# Addendum No. 06

April 11, 2024

## BAKERSFIELD COLLEGE STUDENT HOUSING (for DSA Project Name - New Residence Hall)

**PBK PROJECT NO.:** S2103400AR  
**DSA FILE NO.:** 15-C1  
**DSA APPLICATION NO.:** 02-122124

**A5.1**

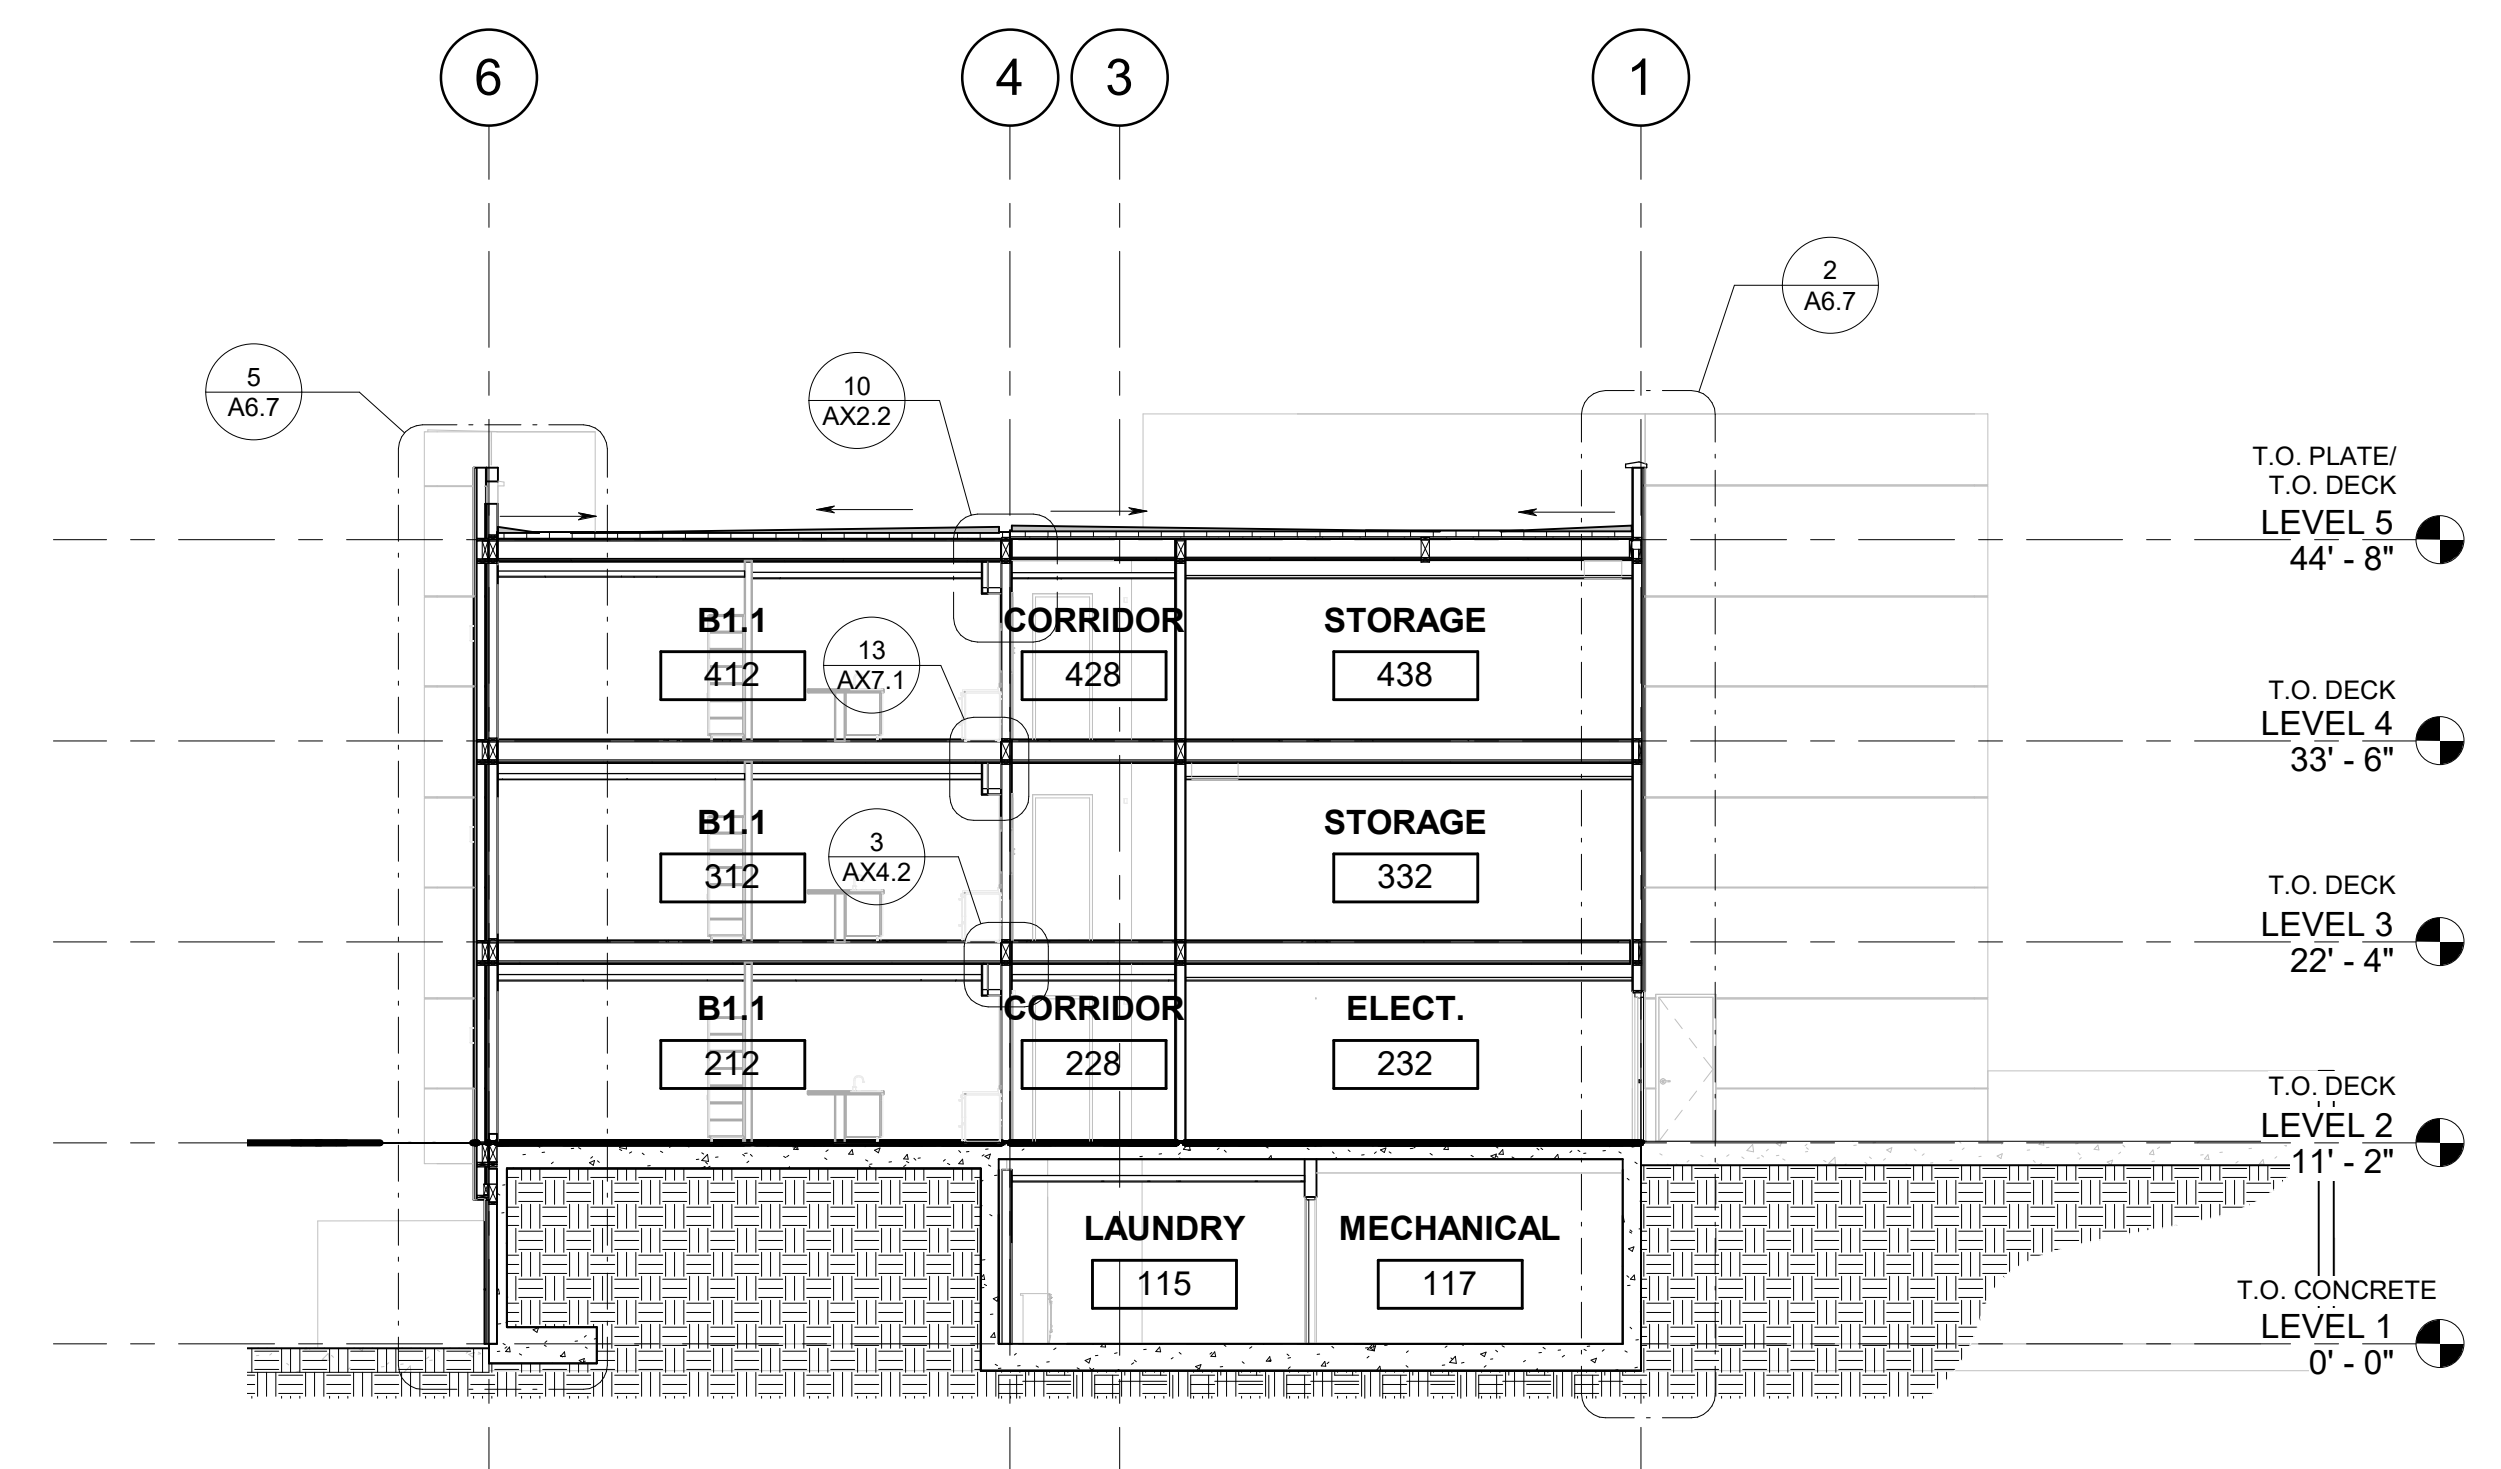
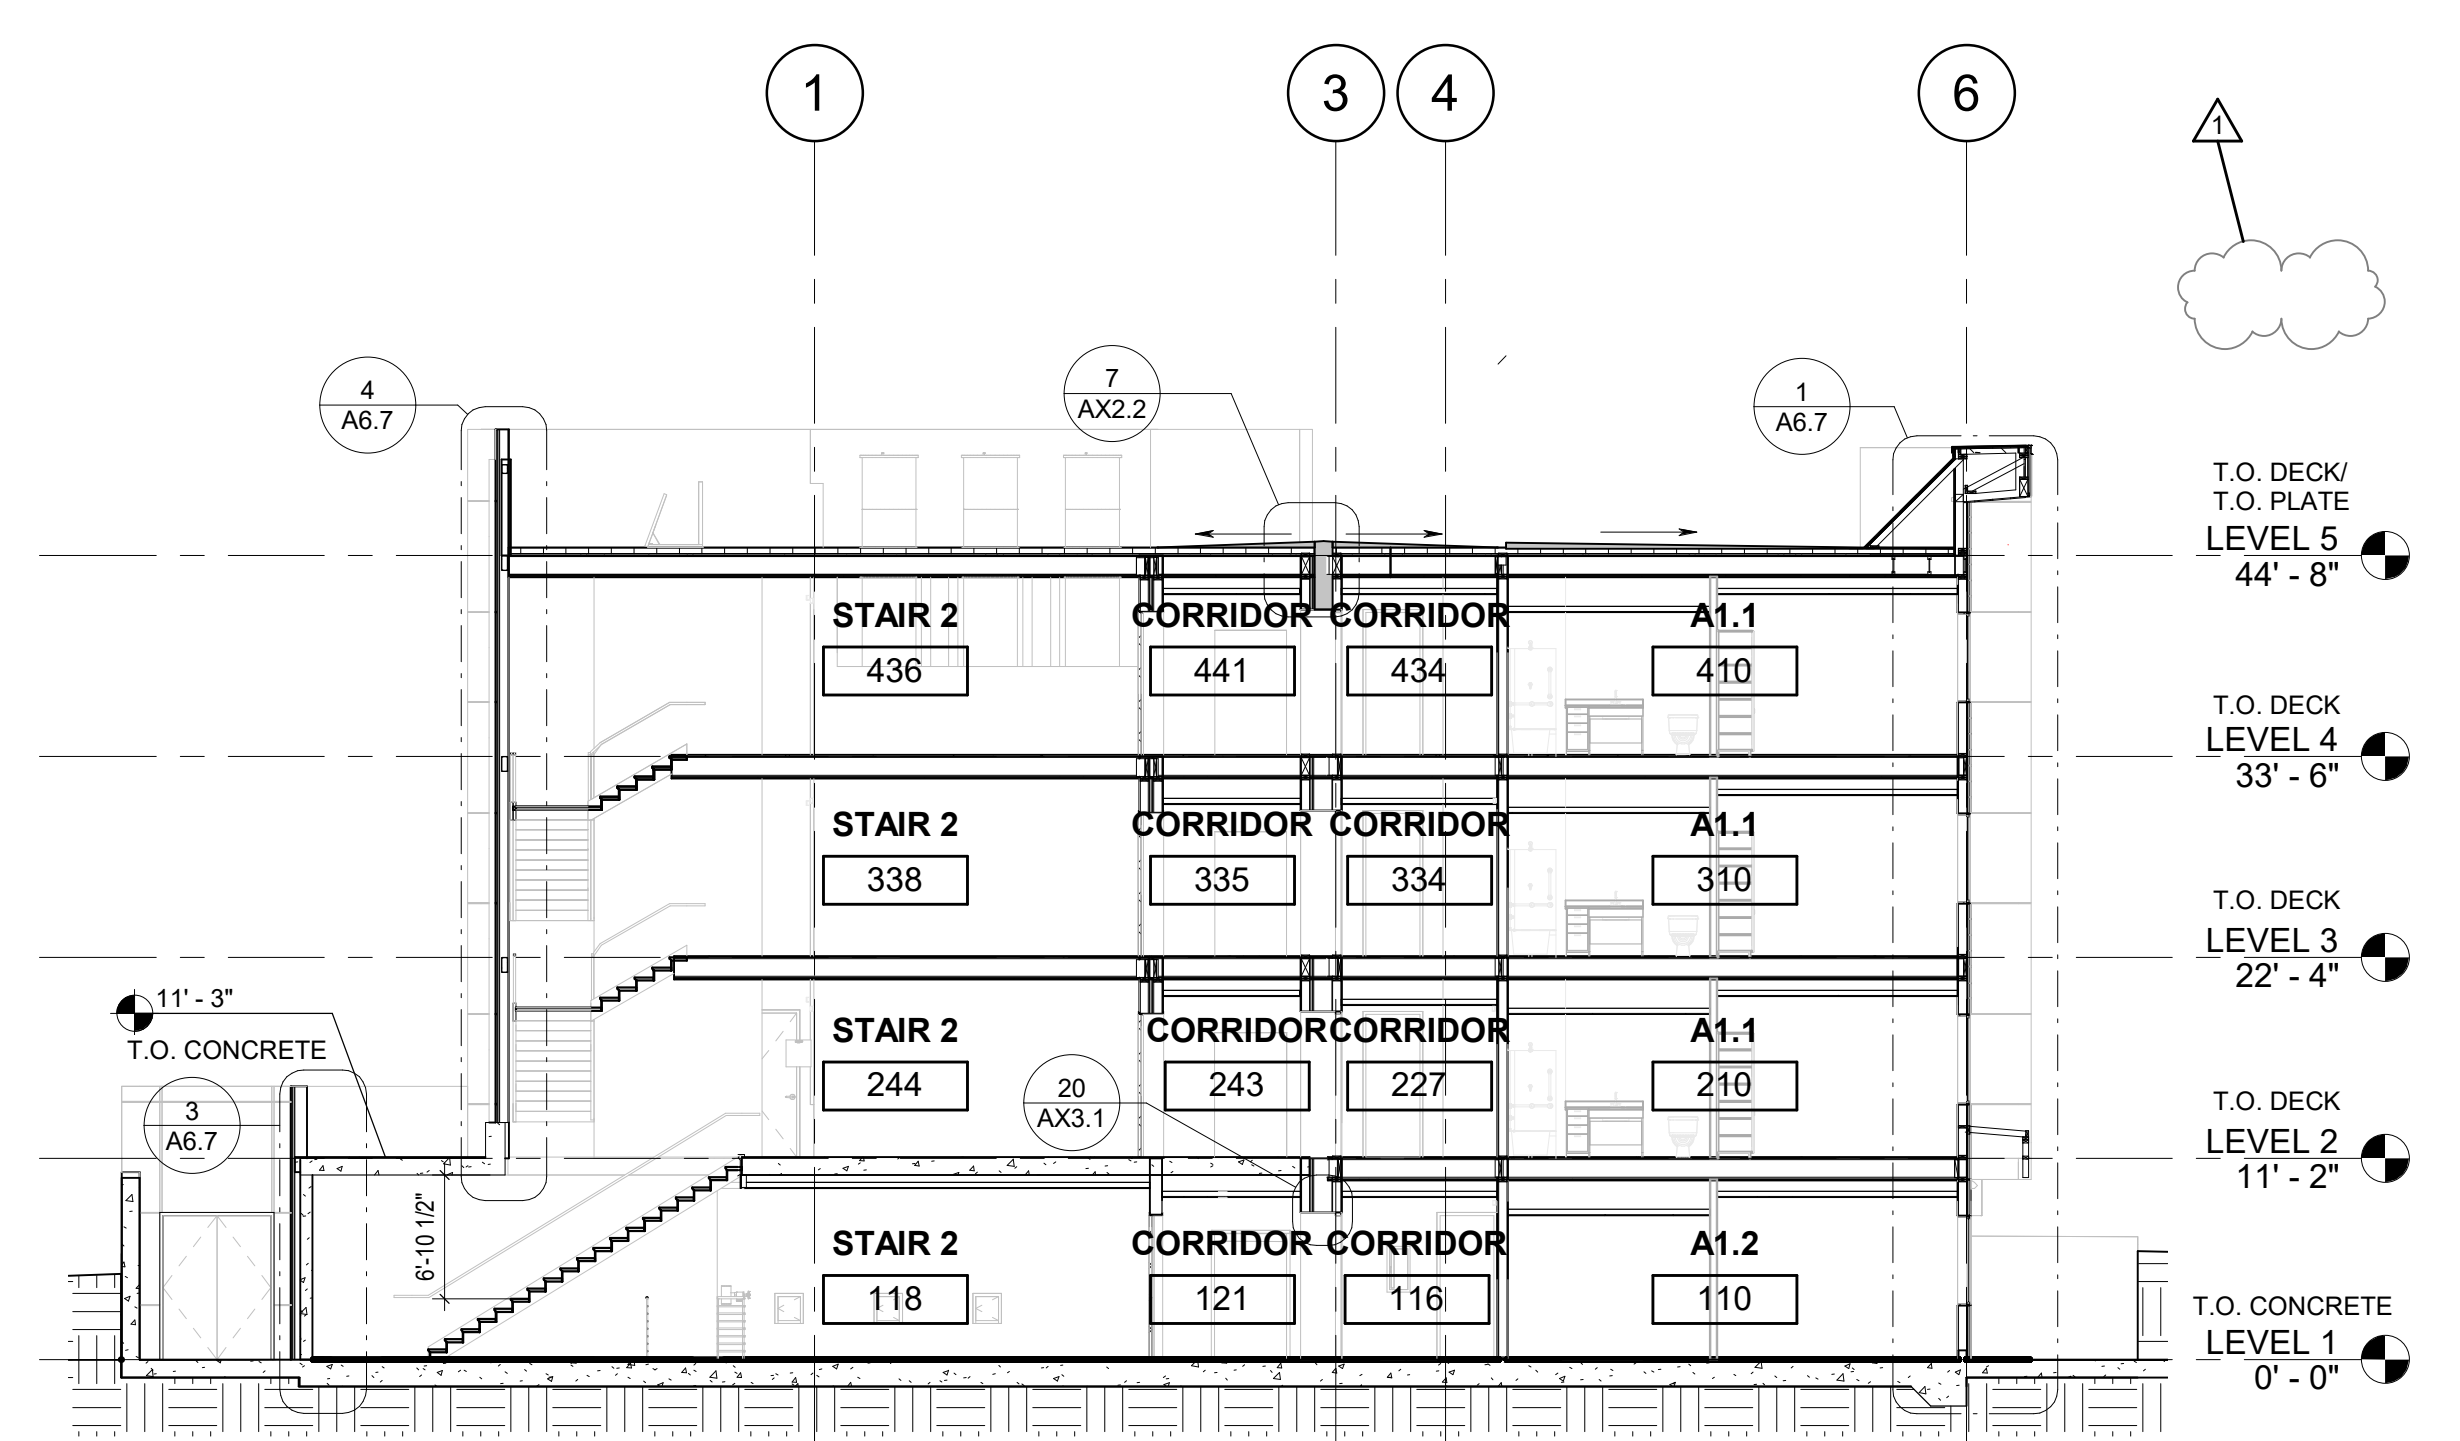
- AD6-16**    **A5.1 – Exterior Elevations:** Replace the sheet in its entirety. Revised detail references and exterior elevation legend. See attached revised drawing A5.1 with all changes clouded.
